**Dispute Resolution Record for EPA's Decision Document for the Time
Critical Removal Action at the San Jacinto River Waste Pits Superfund Site**

SUBJECT: Decision Document for the Time Critical Removal Action at the San Jacinto River Waste Pits Site, Harris County, Texas

B. Modification to Proposed TCRA Alternative 3

Figure 6
Proposed Cover Material - SF = 1.5 and Density = 145 pcf
100-year Flow (372,000 cfs), Lower-Bound Stage Height
San Jacinto River Study Area

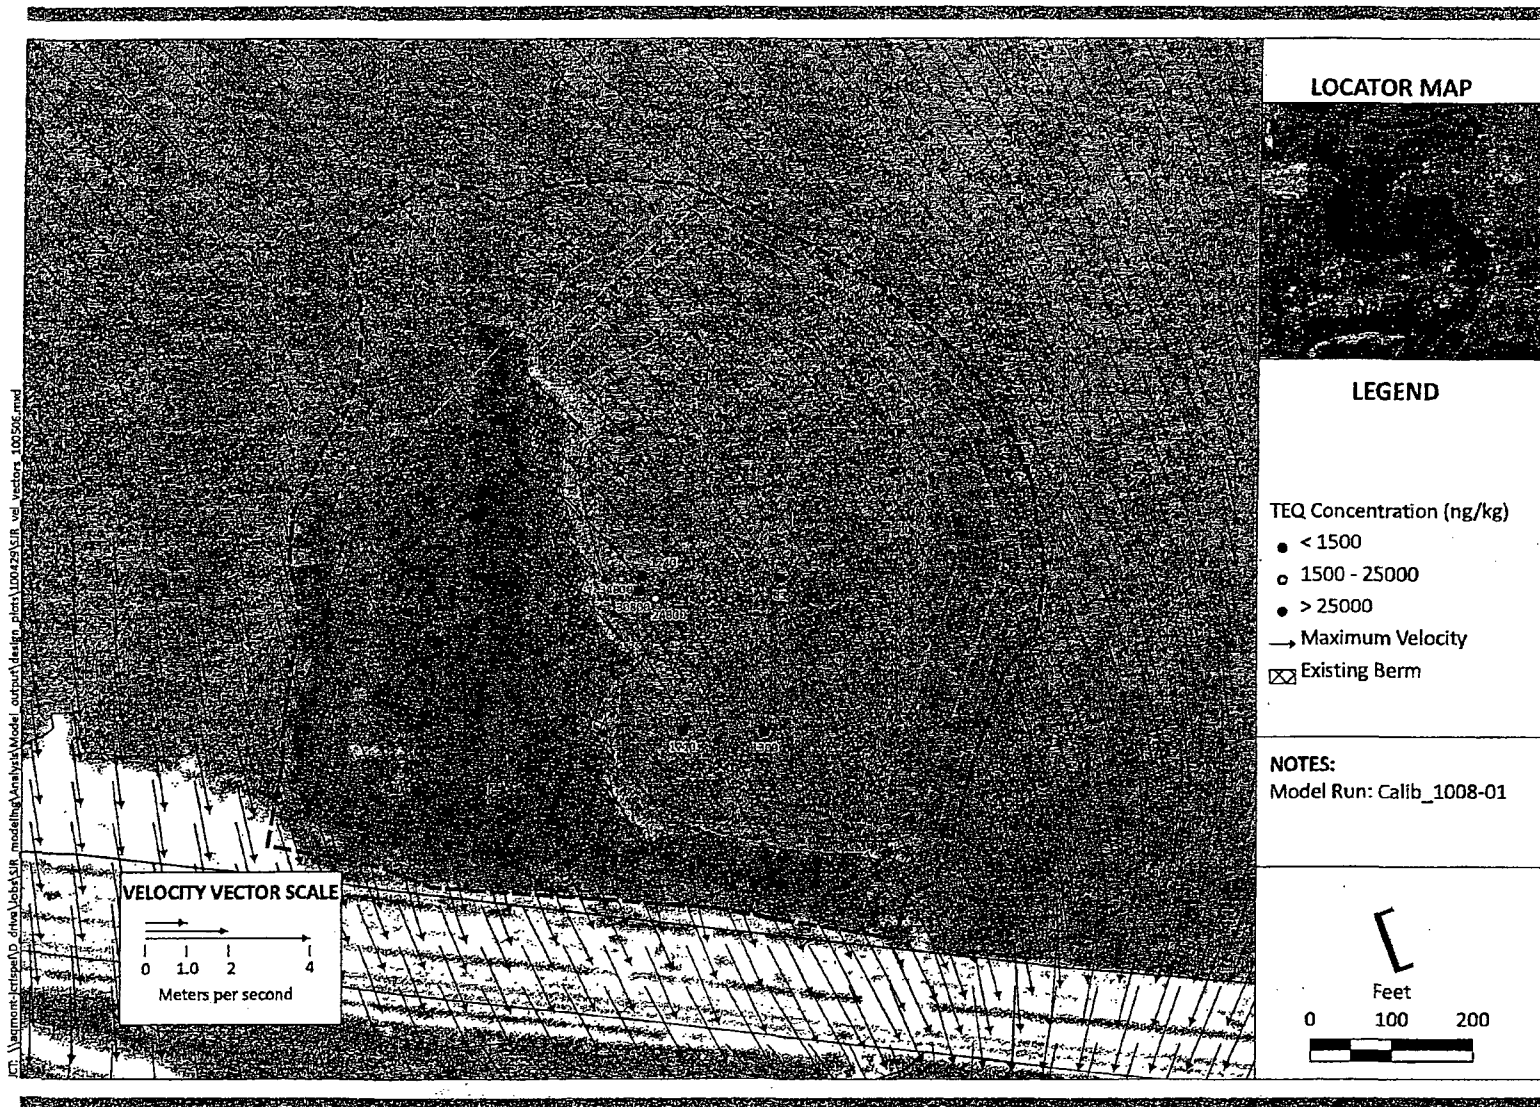
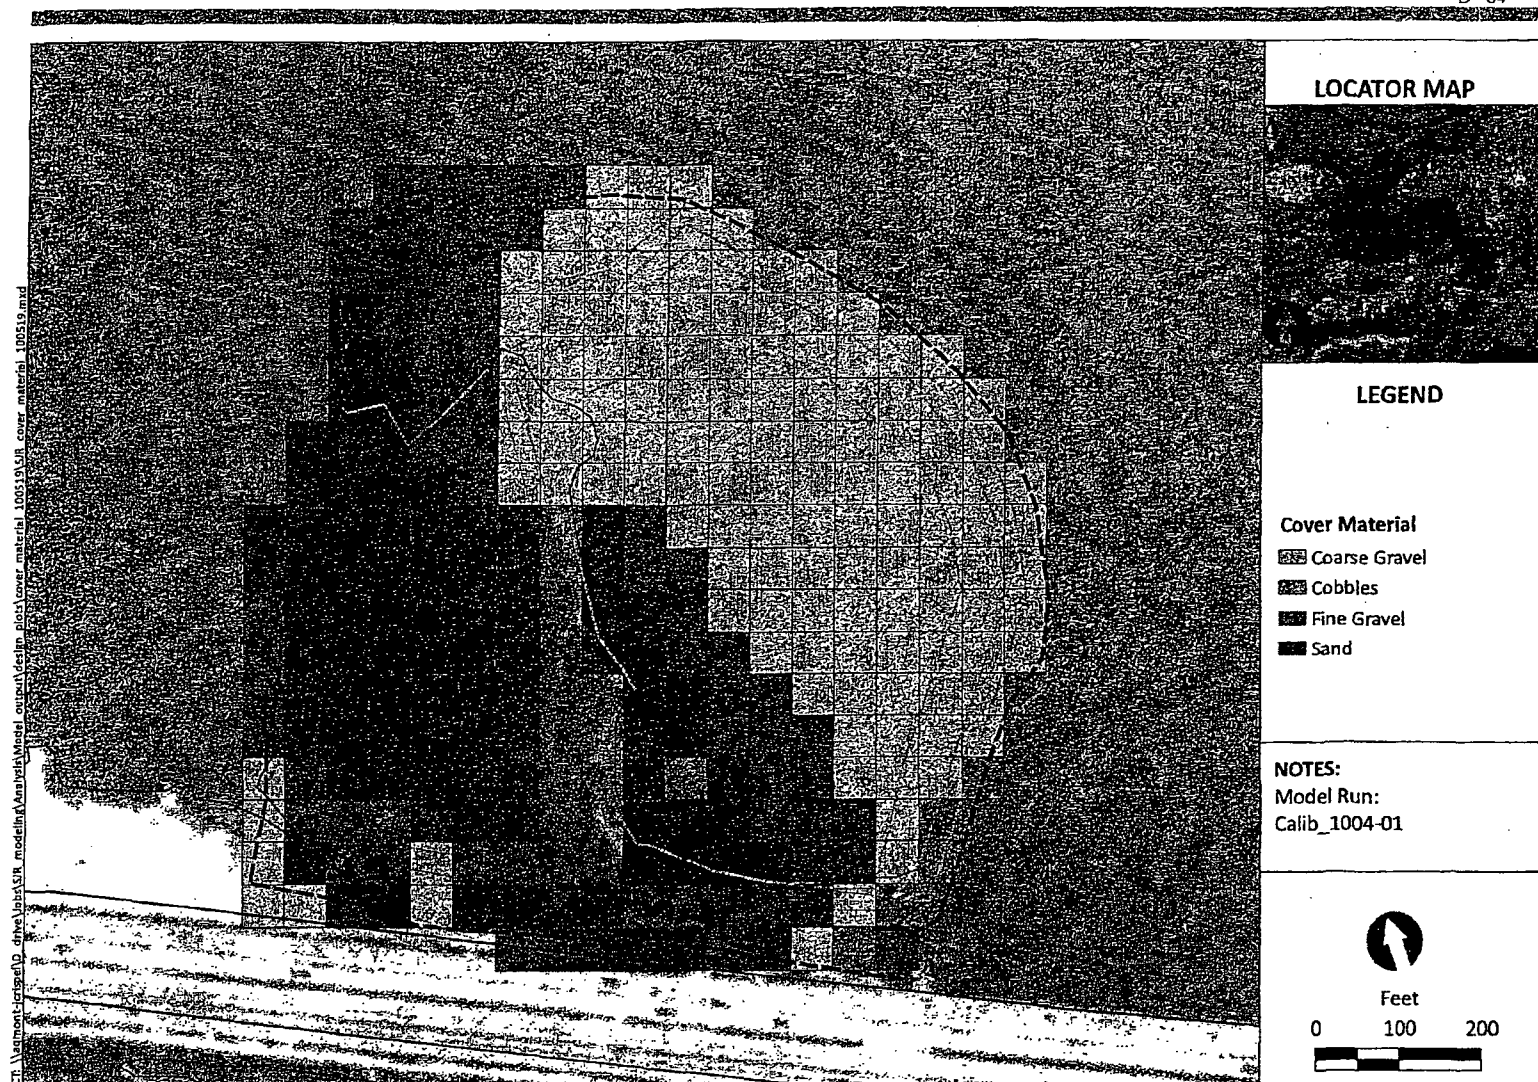
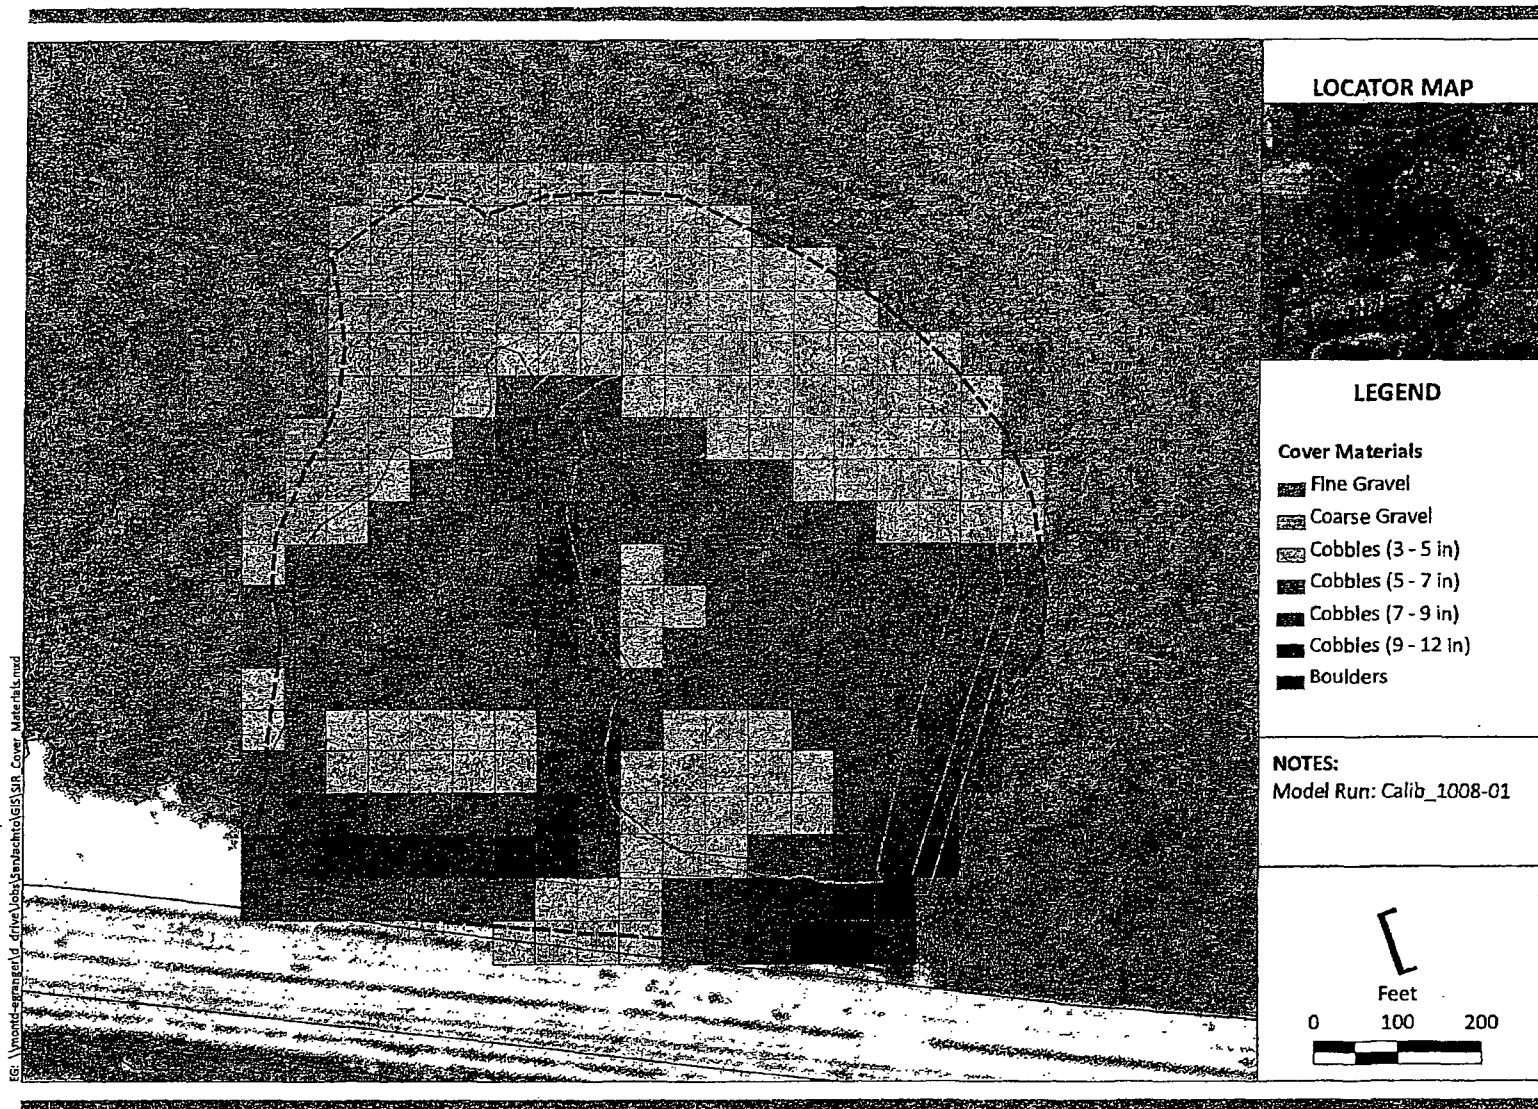
At the August 11, 2010 meeting, Respondents presented to EPA a chart, included as the last page of the attached Exhibit 2, demonstrating the significant difference in the cap design, placement options/equipment, stockpile/laydown area, compatibility with other remedial options, cost, construction days, and remedial action work plan days created by changing from a 10-year flow design to a 100-year flow design.

<u>Changed Item</u>	<u>10-year Flow Design</u>	<u>100-year Flow Design</u>
Cap Gradation D ⁵⁰ Inches	2-inch	4 to 8-inch
Cap Thickness Inches	6-inch (min)	8 to 16-inch (min)
Cap Surface – Square Feet	314,000 (7.2 acres)	452,000 (10.4)
Cap Volume – Cubic Yards (Tons)	13,100 (21,000 Tons)	25,500 (41,600 Tons)
Placement Options/Equipment	Hydraulic (pump) and Mechanical	Mechanical
Stockpile/Lay Down Area		Increased 50%
Compatibility with Other Remedial Options	<ul style="list-style-type: none"> Removal, CDF or insitu containment are all viable remedies 	<ul style="list-style-type: none"> Strongly favors insitu containment over removal or CDF Move Aggregate to Build CDF? Difficulty for Total Removal.
Cost	\$3.7 to 4.2 mil	\$6.7 to 7.7 mil
Construction Days	60 to 80	150 to 170
Remedial Action Work Plan (days)	30	60

Figure 6
Proposed Cover Material - SF = 1.5 and Density = 145 pcf
100-year Flow (372,000 cfs), Lower-Bound Stage Height
San Jacinto River Study Area

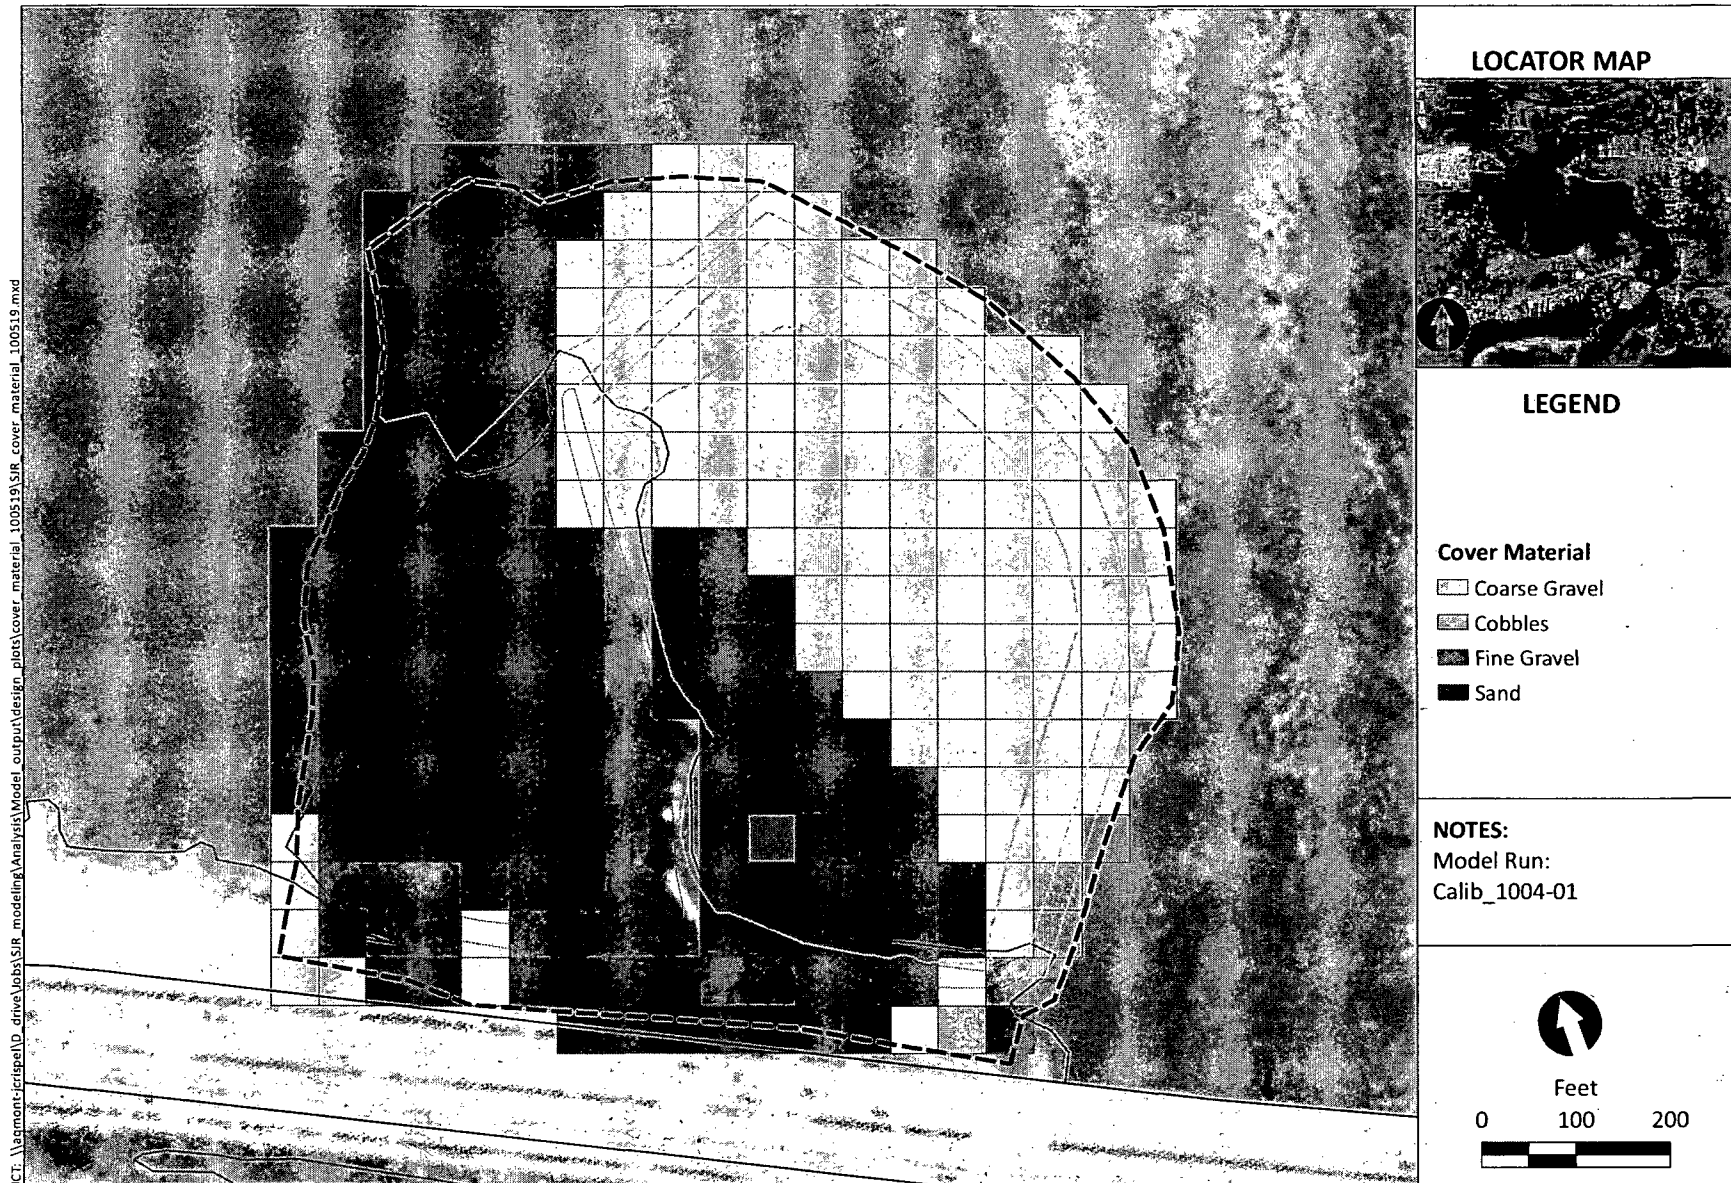
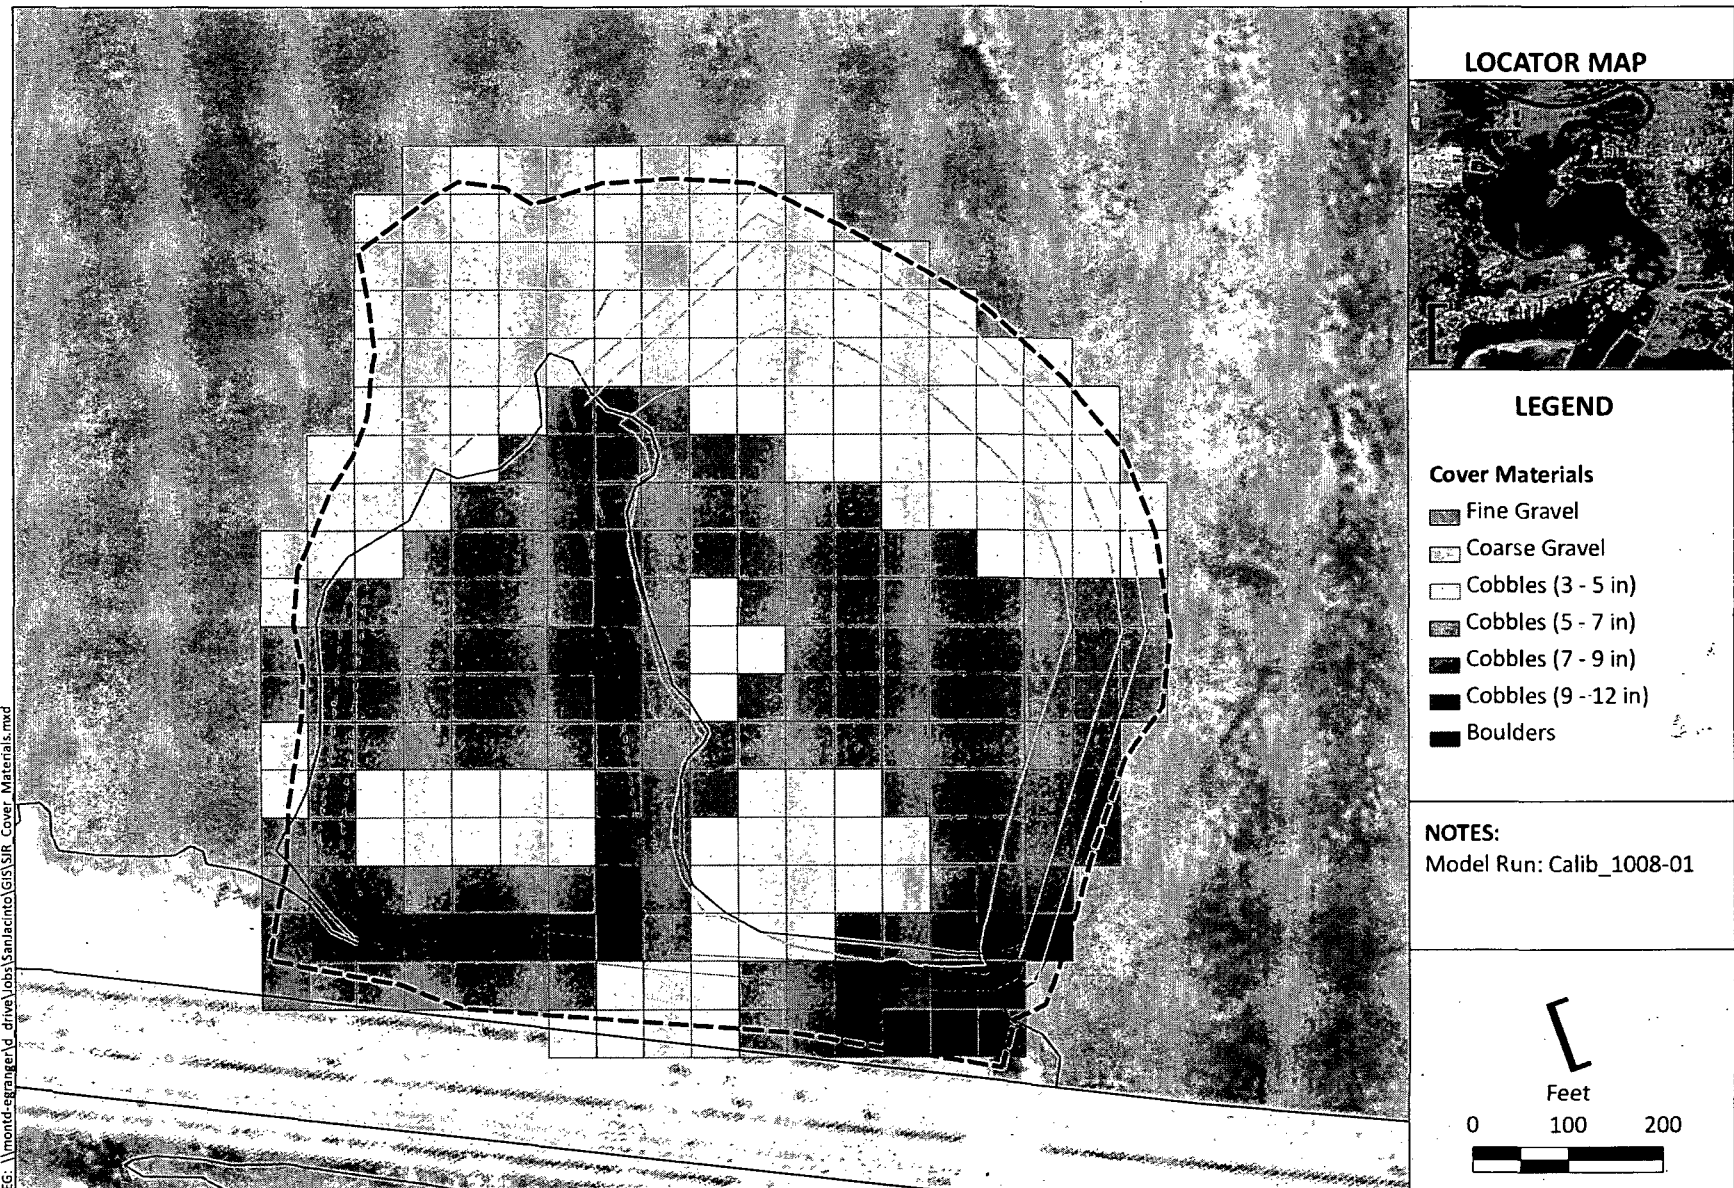
<u>Changed Item</u>	<u>10-year Flow Design</u>	<u>100-year Flow Design</u>
Cap Gradation D ⁵⁰ Inches	2-inch	4 to 8-inch
Cap Thickness Inches	6-inch (min)	8 to 16-inch (min)
Cap Surface – Square Feet	314,000 (7.2 acres)	452,000 (10.4)
Cap Volume – Cubic Yards (Tons)	13,100 (21,000 Tons)	25,500 (41,600 Tons)
Placement Options/Equipment	Hydraulic (pump) and Mechanical	Mechanical
Stockpile/Lay Down Area		Increased 50%
Compatibility with Other Remedial Options	<ul style="list-style-type: none"> Removal, CDF or insitu containment are all viable remedies 	<ul style="list-style-type: none"> Strongly favors insitu containment over removal or CDF Move Aggregate to Build CDF? Difficulty for Total Removal.
Cost	\$3.7 to 4.2 mil	\$6.7 to 7.7 mil
Construction Days	60 to 80	150 to 170
Removal Action Work Plan (days)	30	60

At the August 11, 2010 meeting, Respondents presented to EPA a chart, included as the last page of the attached Exhibit 2, demonstrating the significant difference in the cap design, placement options/equipment, stockpile/laydown area, compatibility with other remedial options, cost, construction days, and remedial action work plan days created by changing from a 10-year flow design to a 100-year flow design.
